Safety Defect and Noncompliance Report Guide for Equipment
PART 573 Defect and Noncompliance Report¹

Furnish the manufacturer's identification code for this recall (if applicable): DOT Recall Number 09V-385

Generic name of the item: 2008 Xebra All Electric Motorcycle

XEBRA RECALL FLUID RESERVOIR

Figure 8. Brake Reservoir

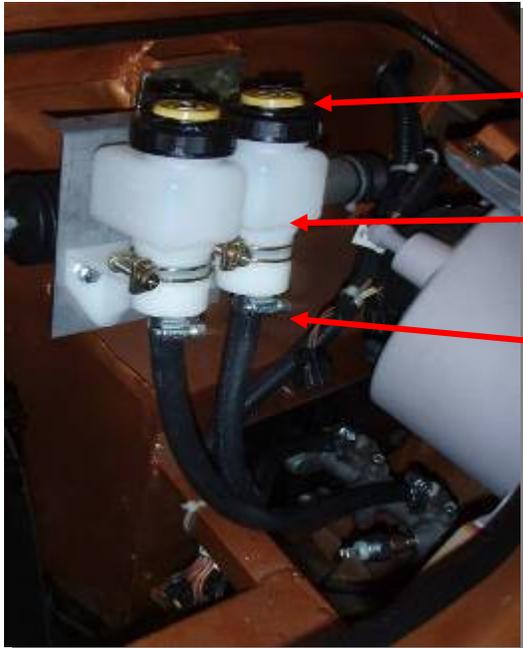
Remove the old brake reservoir and the new ones as shown. You can recycle two of the bolts removed to mount the new reservoir mount plate. Remove as much of the fluid as you can before starting and use a drip pan to catch any fluid that may drip.

Sensor Caps

Individual Reservoirs

Hose Clamp
